# HRRV LP GAS LINE RECALL 14V-254

# Open Range LP GAS LINE RECALL 14V-195

REV										OR OPEN RANGE RV COMPANY 3055 N. 28th SHOPSHEVANA, IN 46563	
I										DESCRIPTION GAS LINE CHANGE	
S										MATERIAL --	
D										FILE WARRANTY & SERVICE	
N										DRAWING NUMBER --	
①										REV --	
MODEL	UF319	DRAWN BY	DUESLER	DATE	5/28/14	SHEET	1 OF 2	NO. OF COPIES	--

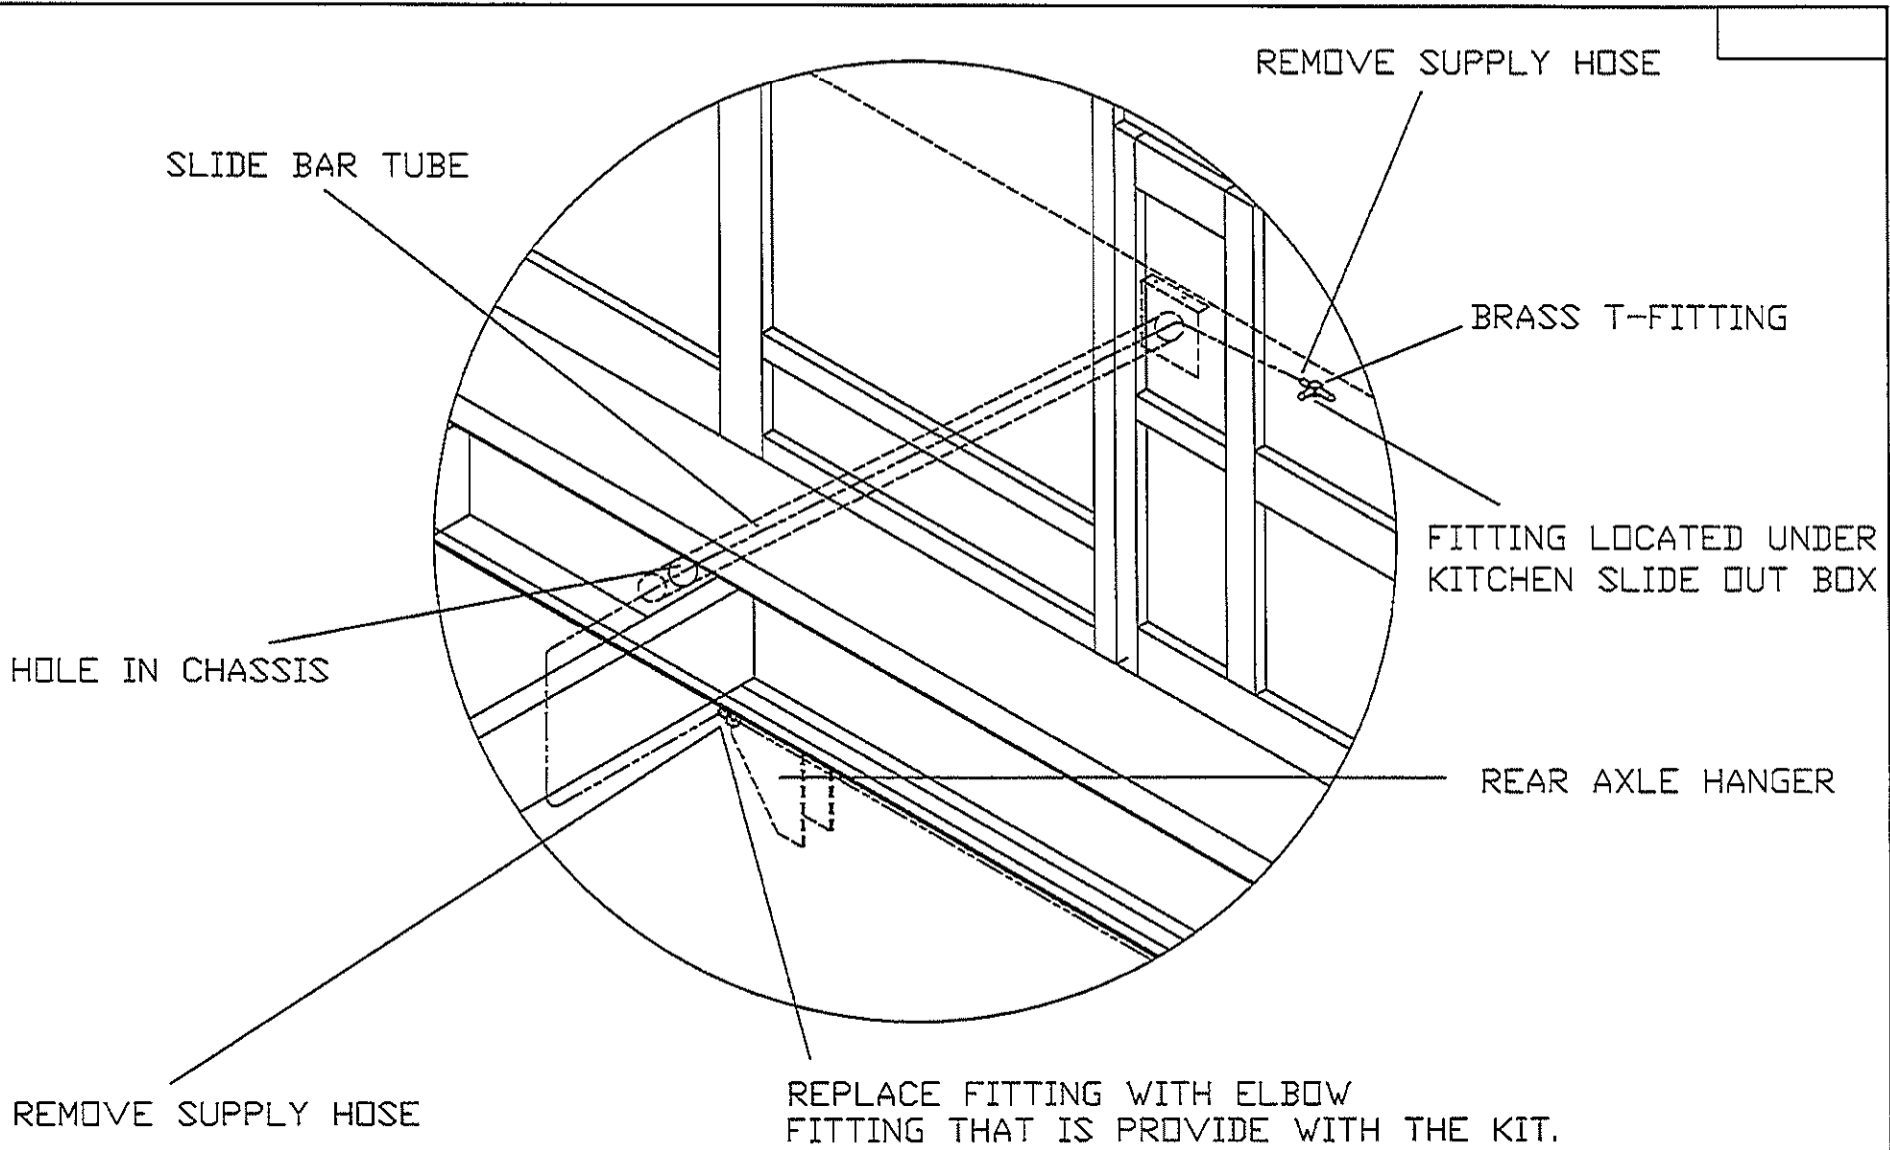
- 1) REMOVE RUBBER GAS SUPPLY LINE FROM FITTING UNDER THE KITCHEN SLIDEOUT. THEN REMOVE THE GAS SUPPLY LINE FROM THE BRASS FITTING LOCATED BY THE TIRE ON THE OFF DOOR SIDE OF THE COACH. LOWER JUST ENOUGH OF THE UNDERBELLY MATERIAL (2-3ft) TO REACH INSIDE AND HELP FEED THE HOSE BACK THROUGH THE PIPE.

- 2) ATTACH THE NEW RUBBER GAS SUPPLY LINE TO THE OLD RUBBER GAS SUPPLY LINE, AND PULL THE LINES THROUGH THE PATH OF THE CURRENT LINE. WHEN THE NEW RUBBER GAS LINE HAS COME THROUGH, DISCONNECT THE 2 LINES FROM EACH OTHER.

- 3) LOOSEN 3 PIPE CLAMPS STARTING AT THE BRASS FITTING THE RUBBER GAS SUPPLY LINE WAS CONNECTED TO BY THE TIRE. THE GAS LINE SHOULD BE LOOSE ENOUGH TO REMOVE THE BRASS FITTING. AFTER REMOVAL OF THE BRASS FITTING, APPLY PIPE COMPOUND TO THE ELBOW FITTING THAT WAS SUPPLIED WITH THE REPAIR KIT, AND ATTACH TO MAIN GAS LINE ALONG CHASSIS.

- 4) CONNECT THE RUBBER GAS SUPPLY LINE TO THE BRASS T-FITTING THAT IS UNDER THE SLIDEOUT, AND CONNECT THE OTHER END TO THE ELBOW FITTING, INSTALLED IN THE LAT STEP, LOCATED ON THE CHASSIS FRAME RAIL.

- 5) AFTER CONNECTIONS ARE MADE, DROP PRESSURE TEST THE LP SYSTEM TO RVIA REQUIREMENTS.
- 6) AFTER THE LP SYSTEM TEST MEETS THE RVIA REQUIREMENTS, THEN REATTACH THE UNDERBELLY MATERIAL, AND RESEAL.

- 7) **THE OLD RUBBER GAS SUPPLY LINE NEEDS CUT IN HALF AND DISCARDED SO IT CANNOT BE USED AGAIN.**
